Addendum No.3

**To Plans, Contract Documents and Specifications
IFB 16-022/JW, Taxiway D Reconstruction (2016)**

TAXIWAY D RECONSTRUCTION (2016)

MARKING DETAILS

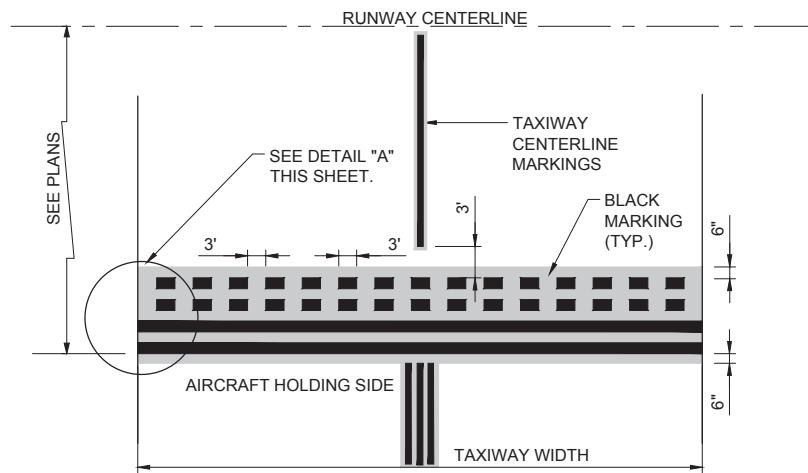
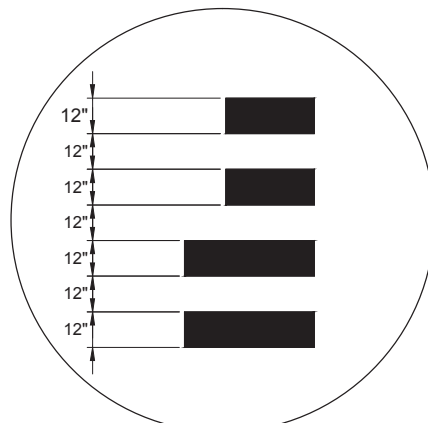
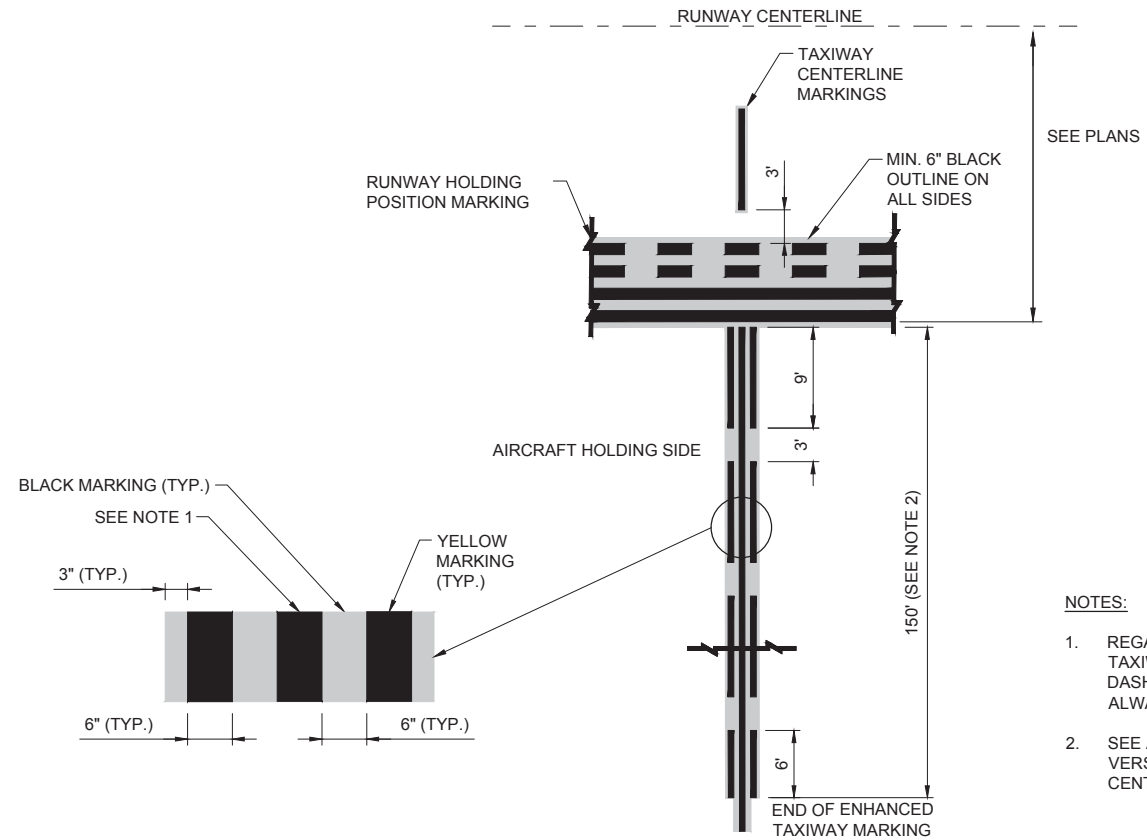
- Proposal pages C-5 to C-14 with the attached pages C-5 to C-14. Removal of the pay item for preformed surface painted sign from item P-620 with adjustments to the paint square footages and the addition of a pay item for the battery backup for the beacon was added as item SS-300-5.2.

- G-102 'Sheet Index and Summary of Quantities' with the attached sheet G-102 'Sheet Index and Summary of Quantities'.
- M-101 'Marking Details' with the attached sheet M-101 'Marking Details'.
- M-103 'Marking and Signage Layout 1' with the attached sheet M-103 'Marking and Signage Layout 1'.
